NACELLE - POWERPLANT - GENERAL SERVICES HARNESS - CLIPPING POINTS - MODIFICATION OF

V2500-A1

71-00-00

V2500-ENG-71-0097

MODIFICATION OF CLIPPING POINTS CP0853 AND CP0857 Figure 1 Sheet 1 of 3

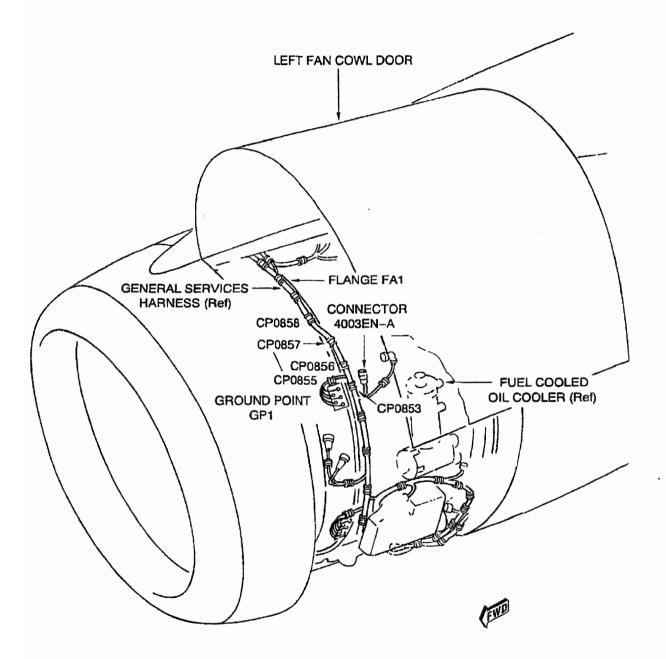
- (1) The changes introduced by this Service Bulletin are as follows:-
 - (a) Clipping points CP0853 and CP0857 on the General Services Harness are disassembled and a 20mm Spacer and longer Bolt is installed at each clipping point.

- A. Pre-requisite Instructions
 - (1) Open the Left Fan Cowl Door as instructed in the A320 Aircraft Maintenance Manual, Task 71-13-00-010-010.
 - (2) Find clipping points CP0853 and CP0857 on the left side of the Engine Fancase (Refer to Figure 1).
- B. Modification Instructions

MODIFICATION OF CLIPPING POINTS CP0853 AND CP0857 Figure 1 Sheet 2 of 3

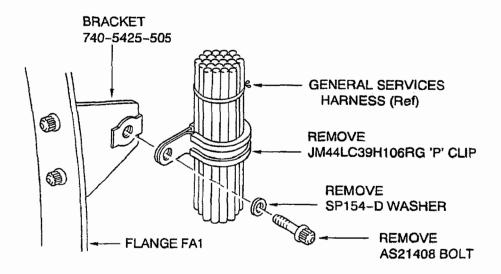
- (1) Remove the AS21408 Bolt, SP154D Washer and JM44LC39H106RG 'P' Clip from the 740-5425-505 bracket at clipping point CP0857 (Refer to Figure 2) Discard the AS21408 Bolt.
- (2) Install the AS21420 Bolt, SP154D Washer, JM44LC39H106RG 'P' Clip and ST1698D50 Spacer to the 740-5425-505 Bracket. Torque the Bolt to 40 lb in (4.52 Nm).
- (3) Remove the AS21408 Bolt, SP154D Washer and JM44LC39H107RG 'P' Clip from the 740-5425-505 Bracket at clipping point CP0853 (Refer to Figure 3). Discard the AS21408 Bolt.
- (4) Install the AS21420 Bolt, SP154D Washer, JM44LC39H107RG 'P' Clip and ST1698D50 Spacer to the 740-5425-505 Bracket. Torque the Bolt to 40 lb in (4.52 Nm).
- C. Post-requisite Instructions
 - (1) Close the Left Fan Cowl Door as instructed in the A320 Aircraft Maintenance Manual, Task 71-13-00-410-010.
- D. Recording Instructions

Clip point 0857 **AFTER**

MODIFICATION OF CLIPPING POINTS CP0853 AND CP0857 Figure 1 Sheet 3 of 3

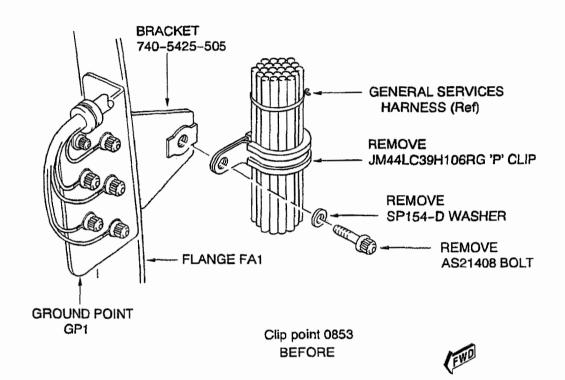
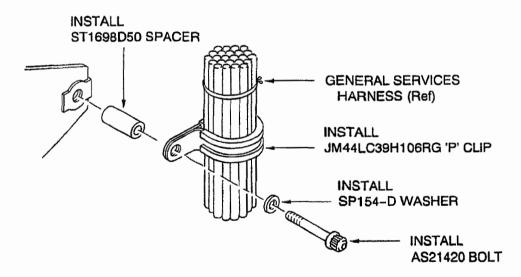
Clip point 0853 AFTER
